Building Consistency Meeting

Commercial

Date 11/05/2014 Recorder and minutes prepared by: Jay E. Garbus/Lon McSwain

SUBJECT: WOOD FRAMED CONSTRUCTION-INTERSECTING WALLS & WRAPPED OPENING

Lesser or Non-rated exterior wall intersections

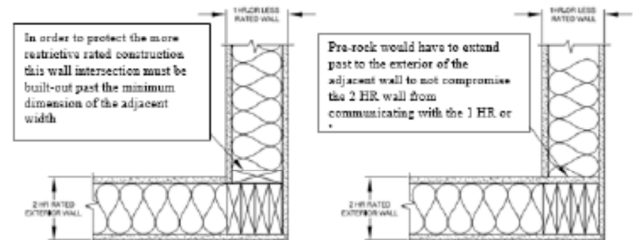
2. Intersecting exterior rated walls lesser or non-rated.

Intersecting rated exterior wall & interior rated or non-rated

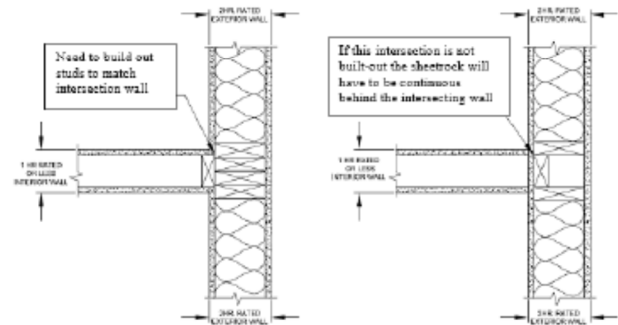
3. Intersecting exterior rated walls with interior rated or non-rated walls.

Intersecting rated with non-rated interior walls, bearing or non-bearing

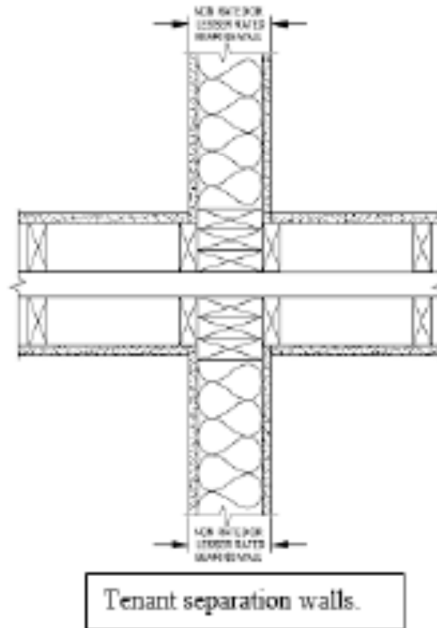
4. Intersecting interior rated walls with non-rated or lesser rating (bearing or non-bearing). Can build-out the studs rather than pre-rock and is allowed on back to back tenant separation walls.

Transfer shower seat

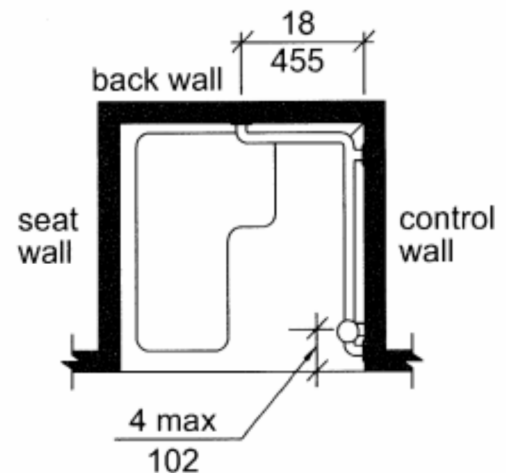
1. Seat backwards
2. Grab bars long leg on wrong wall
3. No vert. Grab bar.

7. Transfer shower seat requirements – See ANSI requirements for showers.
